From: [James Kreft](#)
To: [Plan Commission Comments](#)
Cc: [Evers, Tag](#)
Subject: Oppose: Legistar 86523 (3915 Lien Road (District 3): Consideration of a conditional use)
Date: Monday, March 3, 2025 2:23:42 PM
Attachments: [image.png](#)

Regarding item 86523 (3915 Lien Rd), I see several related issues in the current plans:

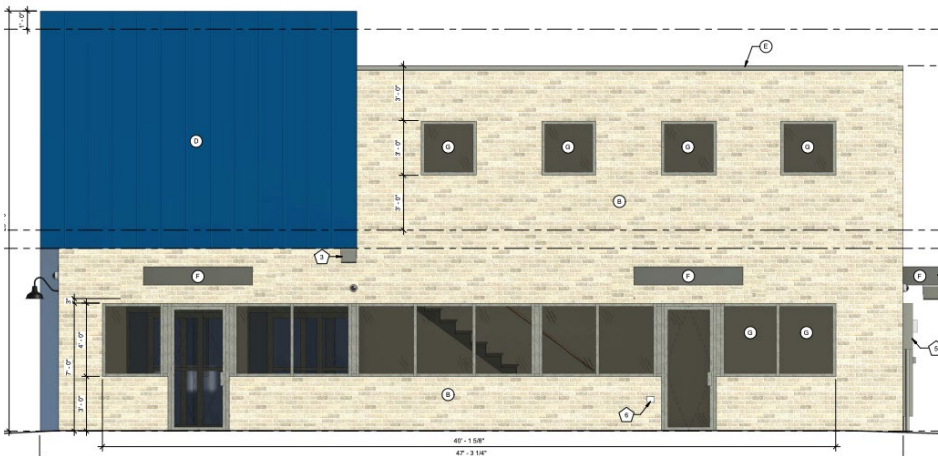
I'm writing in opposition to Legistar 86523. Putting a drive through in the TOD overlay betrays the spirit of what it intends to achieve. While I understand it may technically comply with ordinances and other developments have succeeded in getting approval, it seems that we should update the TOD definition to better implement the spirit of the ordinance. Drive throughs significantly degrade the non-motorist experience and perpetuate the autocentricity of E Wash Ave.

At the very least, please reduce the impact the drive through has on pedestrian access to the business and prioritize the pedestrian experience of walking by the business.
